Camp Victory Lake – Religious Sanctuary
2021/2022 Building Location Modification

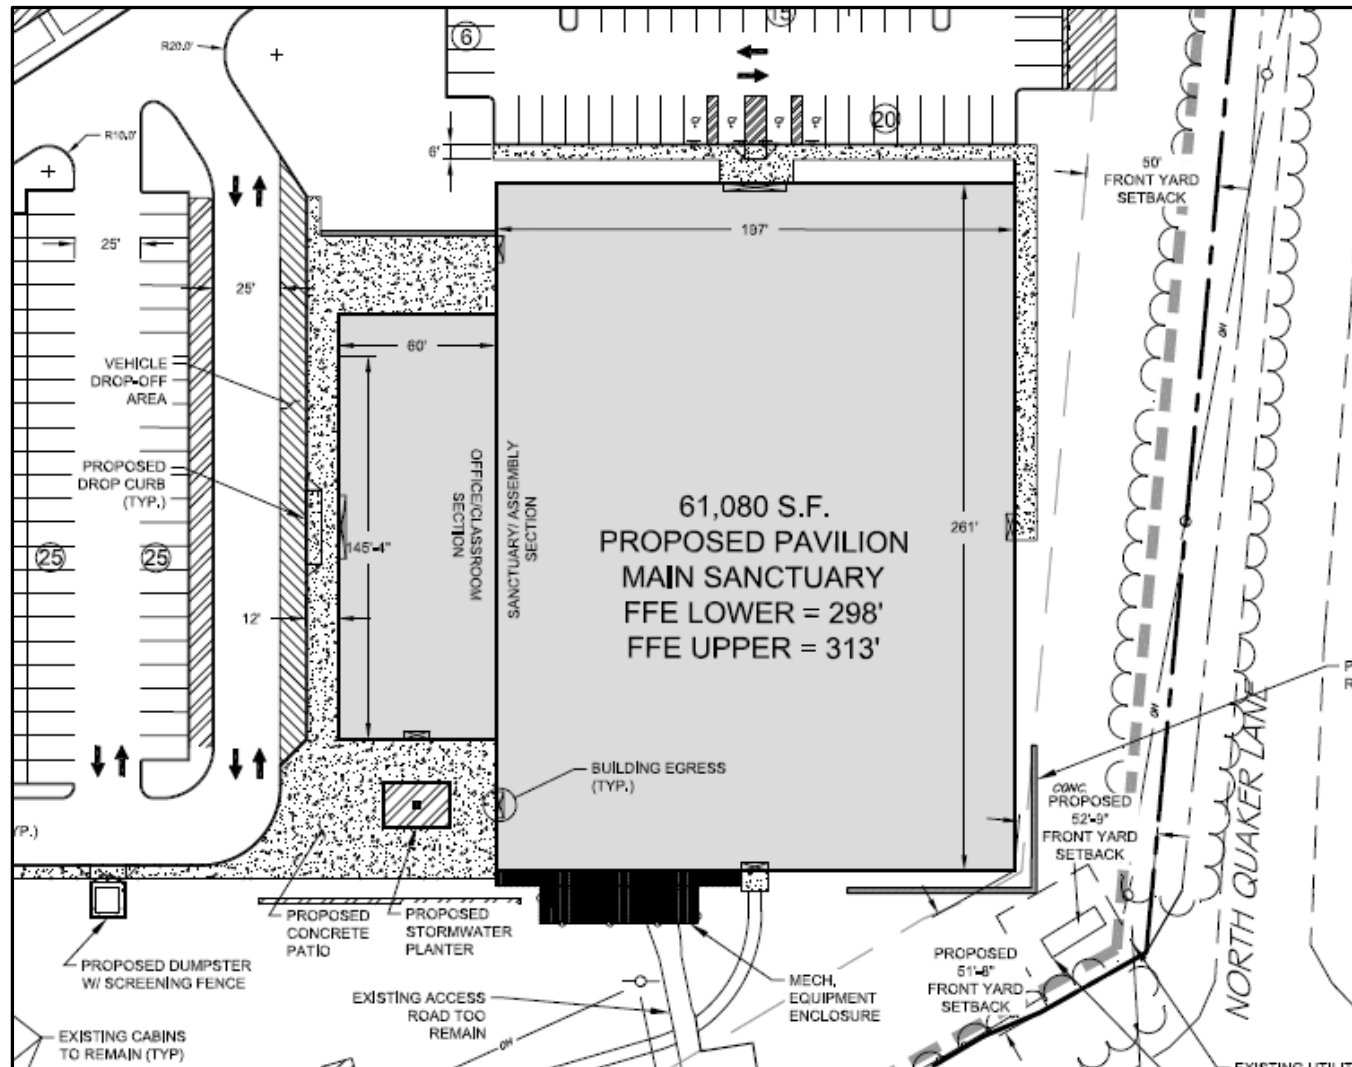
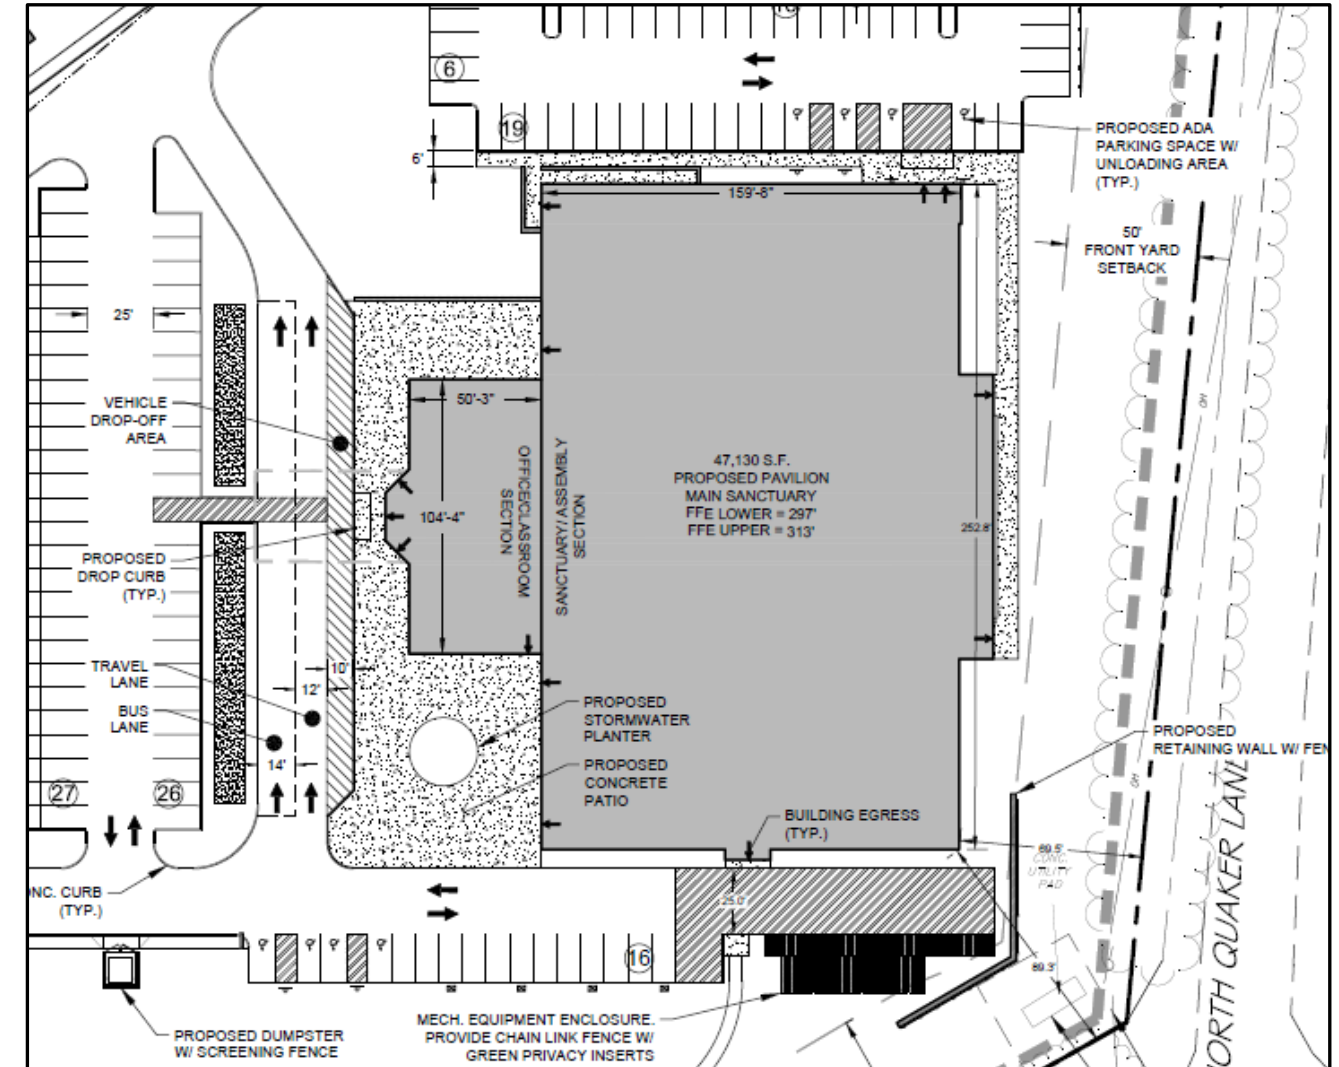
Emergency Access Modifications

- 1) 25' Emergency vehicle access lane added to the South of the Structure.
- 2) 20' of additional clearance provided between structure and retaining wall.
- 3) Building setback from Crum Elbow/North Quaker increased from 51'8" / 52'9" → 89'3.5" / 69'6".

(Modified per Hyde Park Fire District Comments)
